ROAD SAFETY AUDIT

Emerson Drive/Minton Road/Palm Bay Road from Jupiter Boulevard to Culver Drive

Road Safety Audit Report for

Project Title: Emerson Drive Road Safety Audit

Figure 44

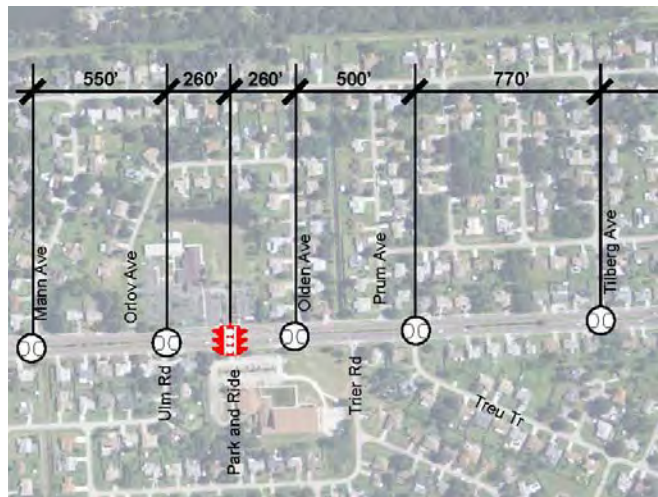
Along Emerson Drive between Coberg Avenue (east of Jupiter Boulevard) and Tilberg Avenue (west of Minton Road), 11 full median openings are present. This stretch of roadway is approximately one mile, which means one full median opening is present approximately every 480 feet with some full medians spaced less than 300 feet apart as displayed in **Figure 43** and **Figure 44**. For this type of roadway, full median openings should be spaced between 1,300 feet and 2,650 feet apart based on FDOT Access Management Rule 14-97. Most of the left-turn lane lengths at these full median openings are shorter than the standard 155 feet needed for proper deceleration along a 40 MPH roadway. Of the 83 crashes that occurred between signalized intersections along Emerson Drive, 64 (77 percent) occurred at or near the 11 full median openings.

- Lengthen the turn lanes for the median openings to meet the standard deceleration distance based on FDOT Design Standard Index 301.
- At U-turn only median openings that do not have left-turn lanes, install a left-turn lane or close the opening.
- Due to their close proximity to the Park and Ride Lot signalized intersection, remove the left-turn lanes at Ulm Road and Olden Avenue. This would allow the left-turn lanes at the Park and Ride Lot intersection to be extended to meet deceleration guidance. Displaced left-turns that would now be U-turns would need to be accounted for at either the signalized intersection or downstream median openings.

Figure 59

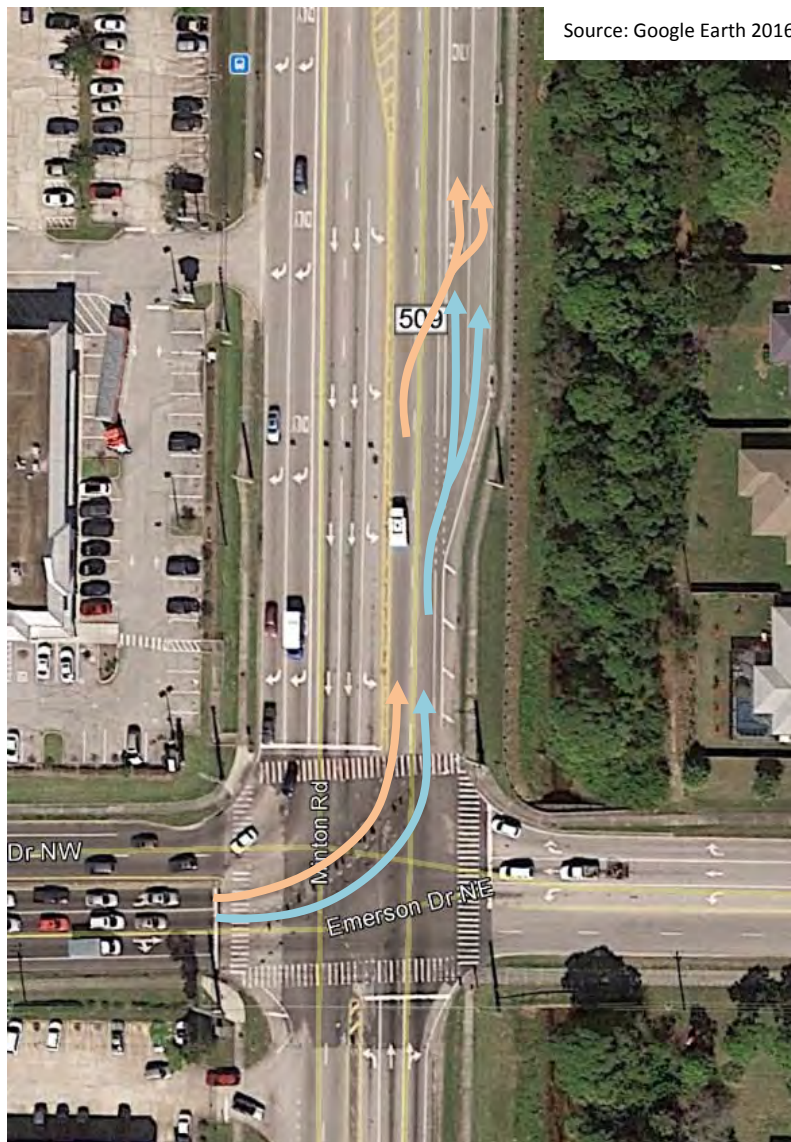
The dual eastbound left-turns at the Emerson Drive/Minton Road intersection are guided into the two northbound through lanes along Minton Road, as illustrated in **Figure 59**. From field observations, most of the vehicles in the outside left-turn lane (blue line) merge into the two northbound right-turn lanes that develop just north of the intersection. The study team observed vehicles from the inside left-turn lane (orange line) attempt to also merge across into the northbound right-turn lanes. If a vehicle is already positioned in the inside right-turn lane (blue line), it becomes difficult for someone in the inside through lane to merge into the right-turn lanes (orange line). Representatives from Palm Bay also noted an imbalance in lane utilization for the eastbound left-turn lanes due to this merge situation. By observation, 60 to 75 percent of left-turning vehicles utilized the outside left-turn lane in order to pre-

- Extend the outside northbound right-turn lane south to the Emerson Drive/Minton Road intersection as indicated in **Figure 60**.
- The outside eastbound left-turn lane could be restriped, leading vehicles to the new outside lane (blue line).

- The signing on the eastbound approach would need to be revised, stating the outside left-turn lane is exclusively for right-turn traffic at Palm Bay Road and that the inside lane is for Minton Road northbound through or right-turn traffic at Palm Bay Road.

- A third northbound lane could be added at the Emerson Drive/Minton Road intersection. This third lane would exclusively serve northbound right-turn traffic at the Minton Road/Palm Bay Road intersection, as well as right-turns onto eastbound Emerson Drive. By adding the third lane, vehicles will be distributed across three lanes thus reducing queueing along the northbound intersection approach.

Figure 61

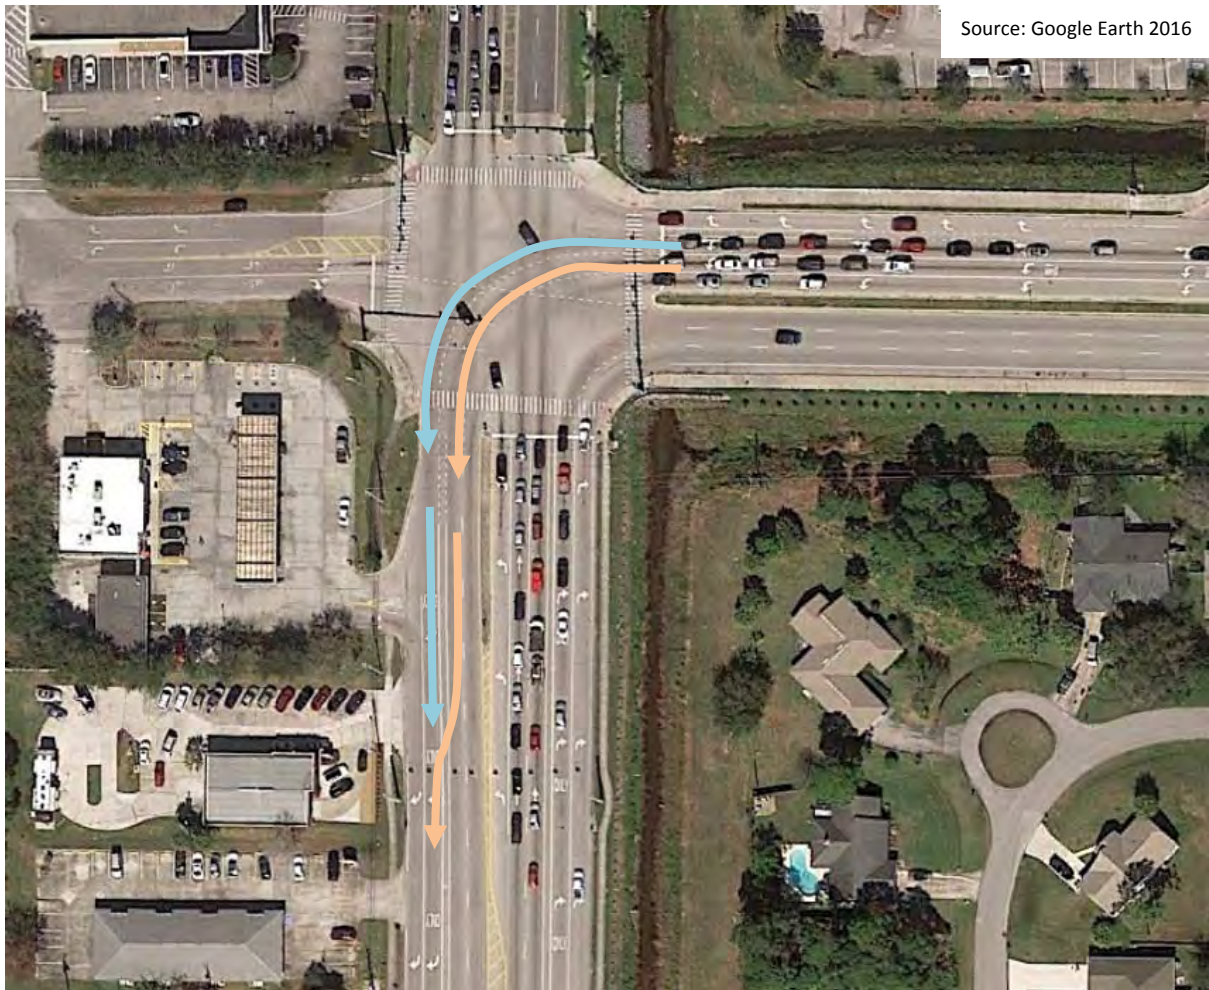
The triple westbound left-turns at the Minton Road/Palm Bay Road intersection are guided into two southbound through lanes and the inside southbound right-turn lane along Minton Road, as illustrated in **Figure 61**. The study team observed vehicles from the middle left-turn lane (orange line) attempt to merge across one or two lanes to get into the southbound right-turn lanes. If a vehicle is already positioned in the inside southbound right-turn lane (blue line), it becomes difficult for someone in the southbound through lane to merge into the right-turn lanes (orange line). The study team observed an imbalance in lane utilization for the westbound left-turn lanes due to this merge situation. By observation, 50 to 60 percent of left-turning vehicles utilized the rightmost left-turn lane and 20 to 30 percent utilized the middle left-turn lane in order to pre-position themselves for the southbound right-turn movement at Emerson Drive. Fourteen (14) sideswipe crashes occurred within the southbound dual right-turn lane area between Palm Bay Road and Emerson Drive.

- Extend the rightmost southbound right-turn lane north to the Minton Road/Palm Bay Road intersection as displayed by the red line in **Figure 62**.
- The outside through/left-turn lane could be restriped, leading vehicles to the new rightmost lane (blue line).

- The signing on the westbound Palm Bay Road approach would need to be revised, stating the rightmost and middle left-turn lanes are exclusively for southbound right-turn traffic at Emerson Drive and that the leftmost lane is for southbound through traffic at Emerson Drive.

- Special attention should be given for accommodating bicycles and pedestrians with the suggestion configuration.

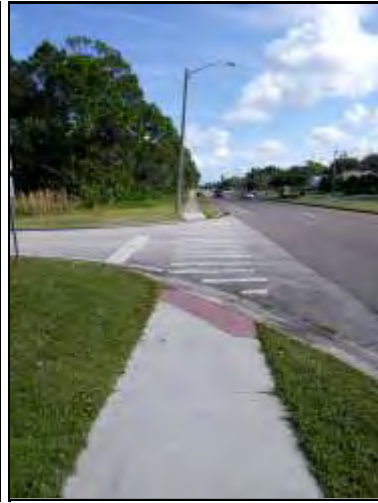
Recommendations: Pave a level 5'x4' slab between the curb and sidewalk to complete a 5'x8' B&A area. Make sure the pole with the bus schedule is located adjacent to the pavement so it is accessible.
